HORSHAM DISTRICT COUNCIL CONSULTATION

TO:	Horsham District Council – Planning Dept
LOCATION:	Coombe Cottage Church Road Mannings Heath
DESCRIPTION:	Erection of a two storey 4 bedroom dwelling with associated parking and landscaping
REFERENCE:	DC/26/0088
RECOMMENDATION:	Advice / modification / More info Advice / More info

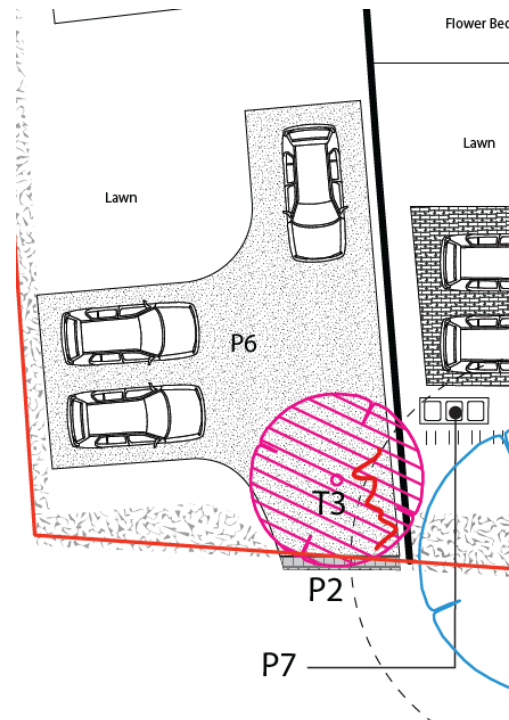
The amended plans (Ref: RH136JE Hard & Soft Landscaping 02), show the retention of the existing slab where the new access is proposed. This is acceptable in principle and should ensure that the root systems of the adjacent trees are not compromised by the new access arrangements.

Regarding the previous points raised in relation to the parking areas and bin stores within the RPA of the yew tree at the front of the property, the retention of the existing slab where the access is proposed will limit the extent of ground disturbance within the RPA, which is a positive outcome.

Furthermore, the retention of the slab, along with the increased separation between the trees in question and the development area, would ensure that the works required to construct the parking bays and bin store, where they fall within the RPA of the yew, will

remain below 20% of new surfacing within the RPA. This would therefore be within tolerable limits under the BS, subject to the new surfacing being constructed using a no-dig method, as is proposed; this can be secured by condition.

I note that the revised plans do not address the previous comments concerning how the new access and parking area for the existing dwelling, to the east of the yew tree, would be constructed; please seek confirmation on this.
